For: MULTIPLE FUNCTION AIRWAY
ADAPTER

Attorney Docket No.: 4502US

LETTER TO THE CHIEF DRAFTSMAN

Applicants submit herewith revised FIGS. 1-2A, 4-7, 10, 12-15, 17, and 20 which correct errors in the drawings. Specifically, FIG. 1 has been revised to change reference numeral 74 to 70; FIG. 2 has been revised to change reference numeral 74 to 70; FIG. 2A has been revised to change reference numeral 254 to 234, to change reference numeral 74 to 70, to add reference numeral 26 with appropriate lead line, and to change the lead line of reference numeral 24; FIG. 4 has been revised to add reference numerals 33, 34 and 242 with appropriate lead lines; FIG. 5 has been revised to add reference numerals 24, 26 and 34 with appropriate lead lines; FIG. 6 has been revised to add reference numeral 33 with appropriate lead line; FIG. 7 has been

Fig. 14

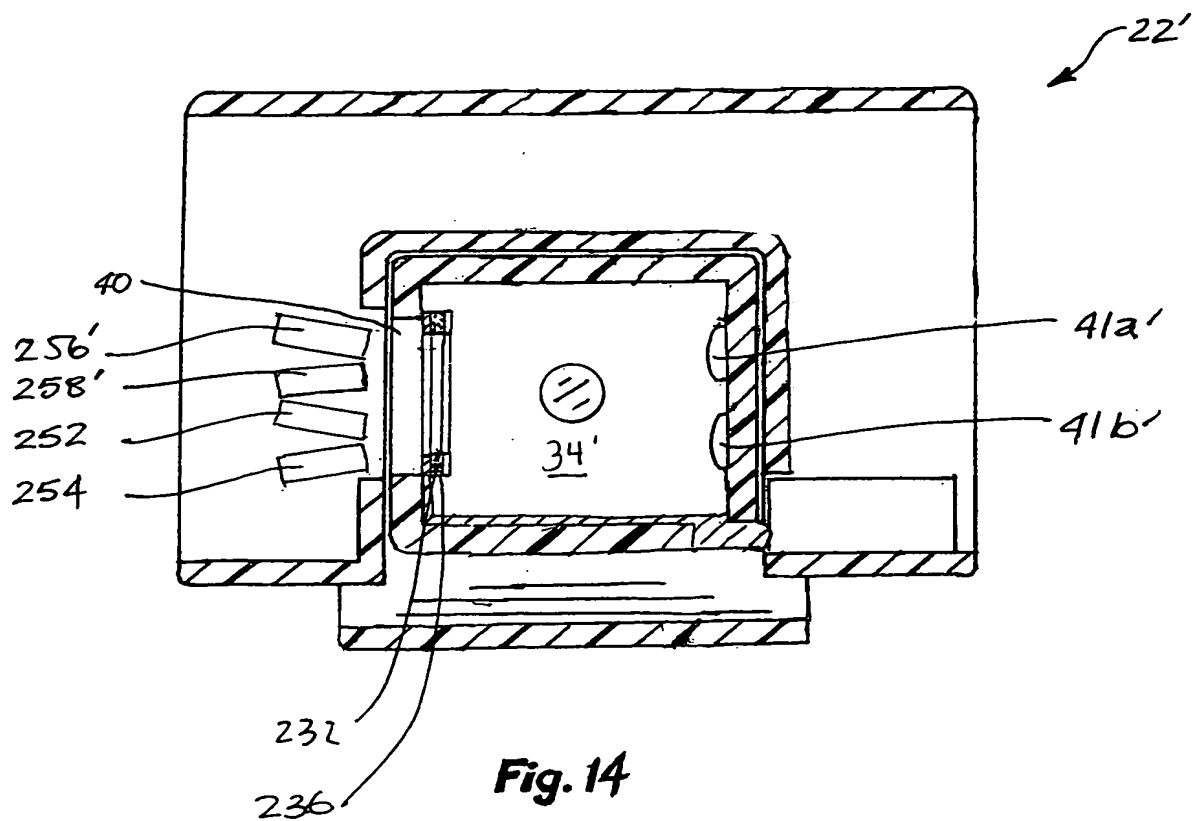
revised to add reference numerals 22a" and 22b" with appropriate lead lines; FIG. 10 has been revised to change reference numeral 42 to 142; FIG. 12 has been revised to change reference numeral 42 to 142; FIG. 13 has been revised to change reference numeral 20 to 20' and to add reference numeral 34' with appropriate lead line; FIG. 14 has been revised to change reference numeral 22 to 22', 256 to 256', 258 to 258' and to add reference numeral 34' to the center of the drawing; FIG. 15 has been revised to change reference numerals 92 to 21, 24 to 24', 20 to 20' and 74 to 70; FIG. 17 has been revised to add reference numeral 143 with appropriate lead line, to change the lead line from reference numeral 138, and to change reference numerals 142 to 141, 120 to 125 and 140 to 145; and FIG. 20 has been revised to add reference numerals 110 and 143 with appropriate lead lines, to change the bottom occurrence of reference numeral 140 to 145 and to delete the top occurrence of reference numeral 140 and accompanying lead line. Attached is a copy of the drawings with the proposed changes marked in red.
